MEMORANDUM

RE: **DRH16-00079/ BVGC Parcel B, LLC**

Public Worksession DRH16-00079/ BVGC Parcel B, LLC

Approval for the construction of a six-story 145,000 square foot office building, a 5,000 square foot retail building, and a four-story 611 stall parking garage including 10,000 square feet of ground floor commercial space.

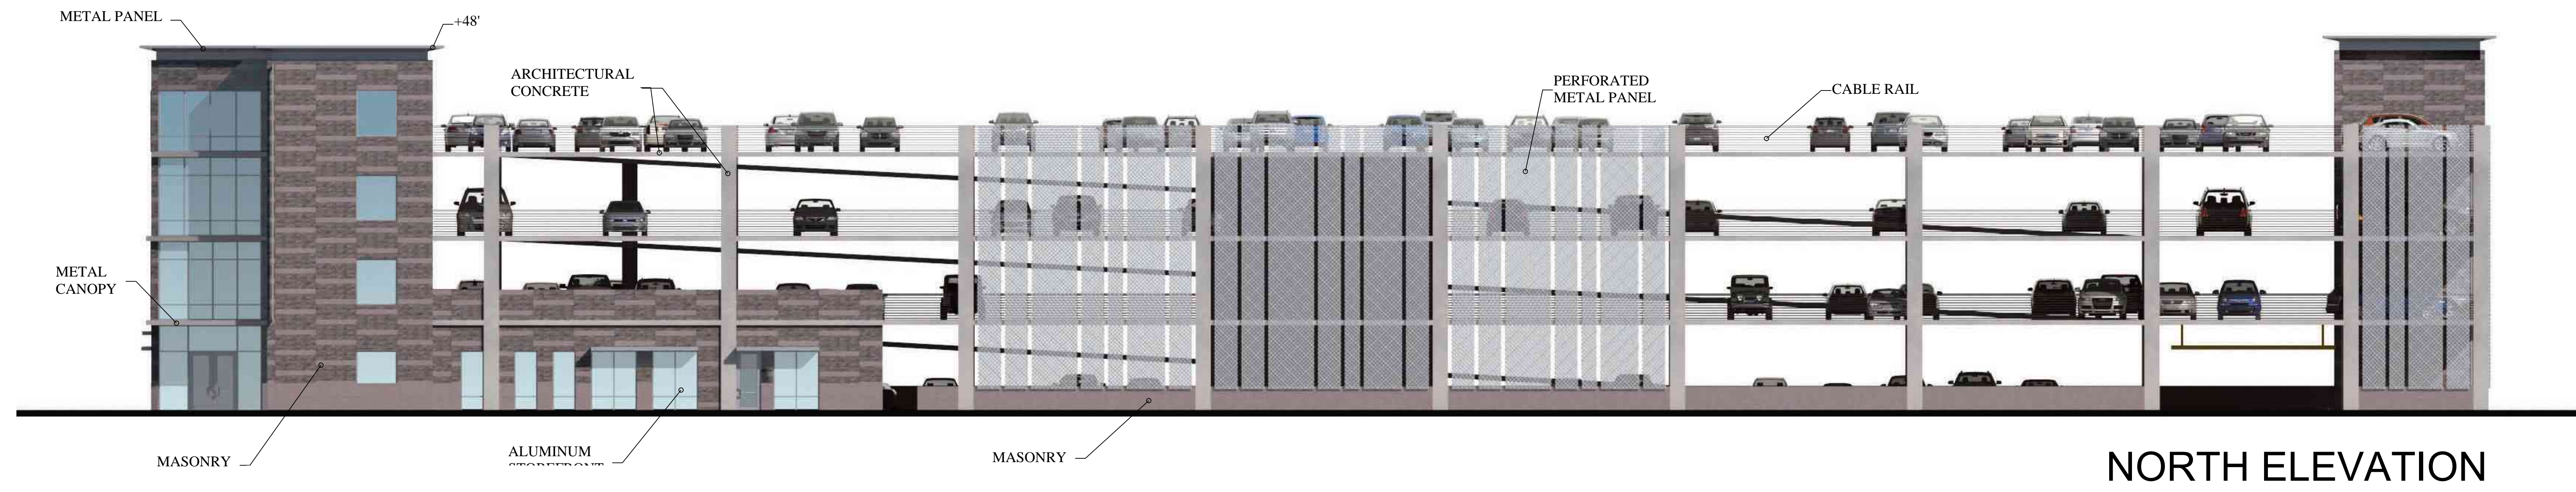
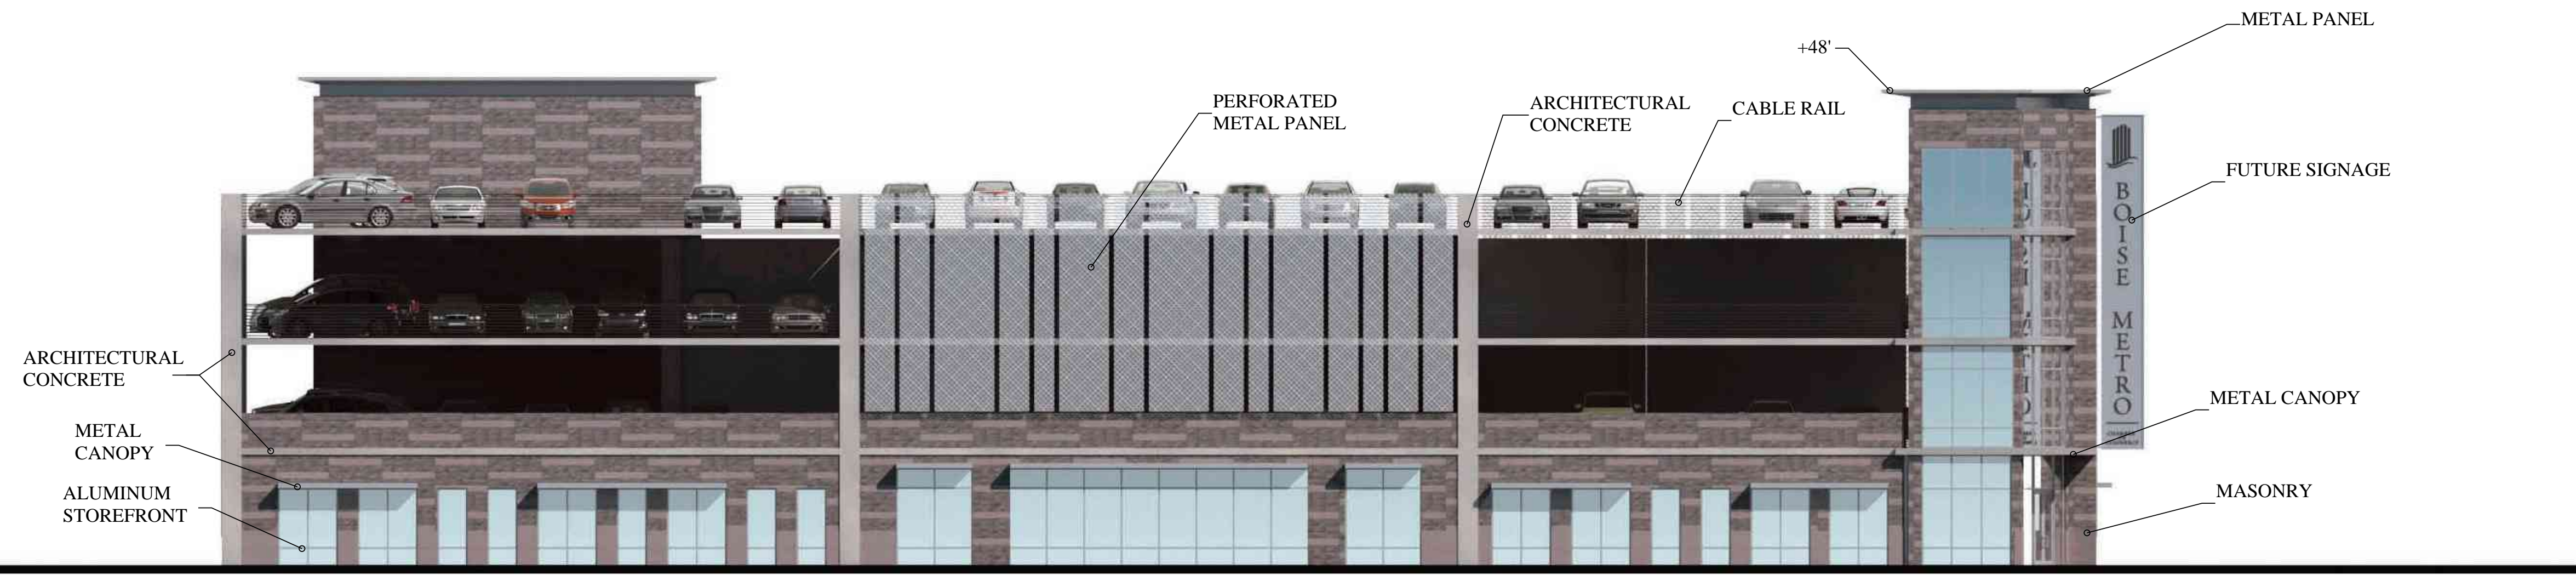
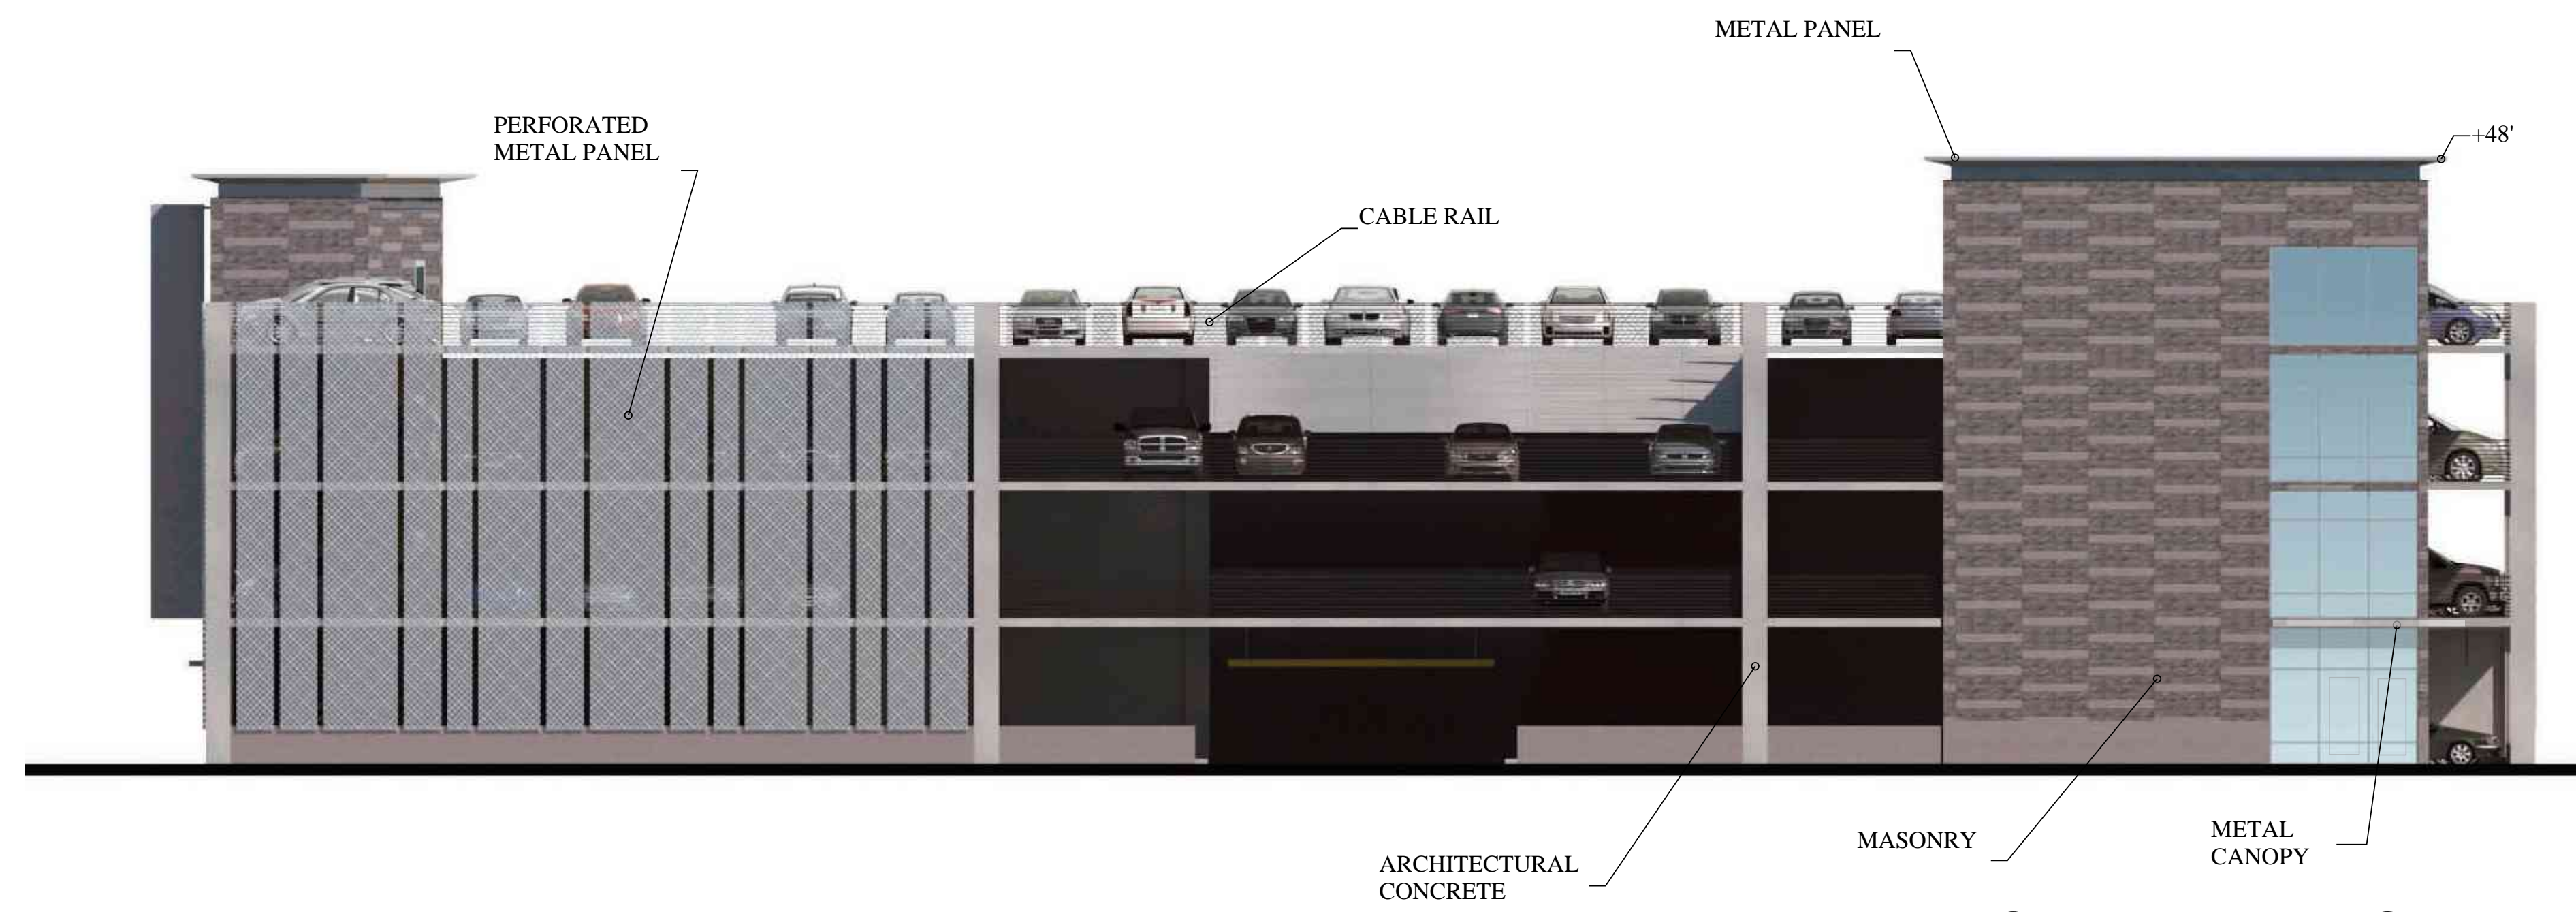
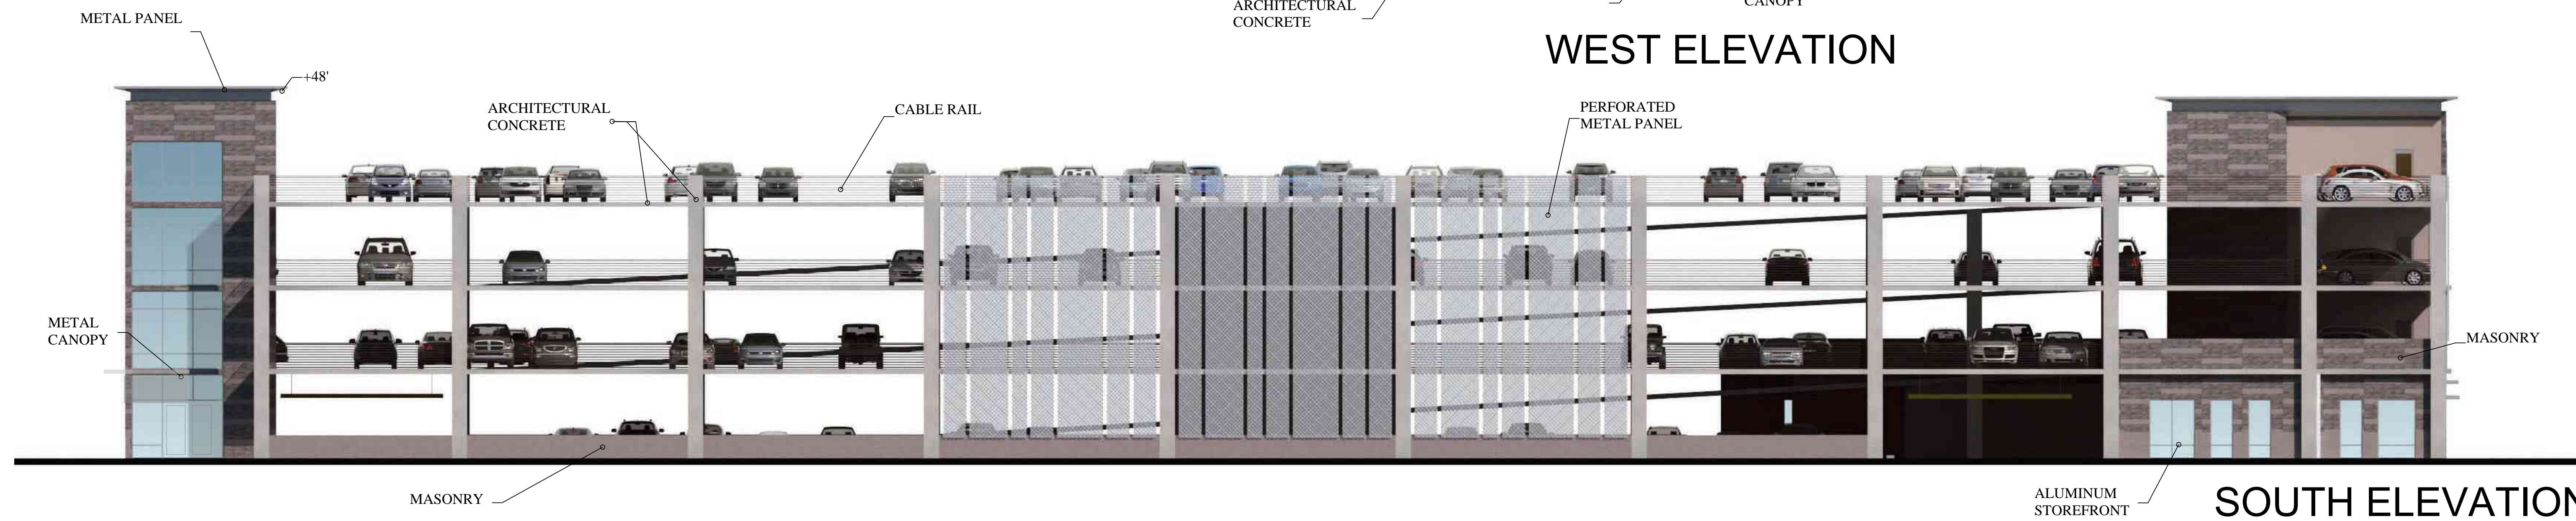
- 1b. Provide a prominent entrance to the Office Building on Myrtle Street. The design shall be reviewed by the Committee at a public work session.**

The office building has been modified to include a building entrance on the south side near the stairwell. The entrance has been styled to mimic the main building entrance on the north elevation, with a metal canopy and glazing. The applicant has not clarified if the entrance will be publicly accessible, and this should be addressed at the public worksession.

1b. Provide a prominent entrance to the Office Building on Myrtle Street. The design shall be reviewed by the Committee at a public work session.

Modification has occurred to the Myrtle Street façade of the Office Building to include an entrance. We are proposing an entrance on Myrtle Street that is similar to the design of the entrance proposed on the north façade of the Office Building. This entrance also permits the stairwell emergency exit to be incorporated into the entrance vestibule screening it from Myrtle Street. As a consequence, it has been necessary to alternate one of the trees on the north side of the sidewalk. However, we believe that placement of an entrance at this location is an appropriate trade off. Both entrances to the Office Building are distinct, defined, and clearly distinguishable as entrances. This satisfies the provisions of Sections 4.2.4 and 4.3.1 of the Boise Downtown Design Standards and Guidelines.
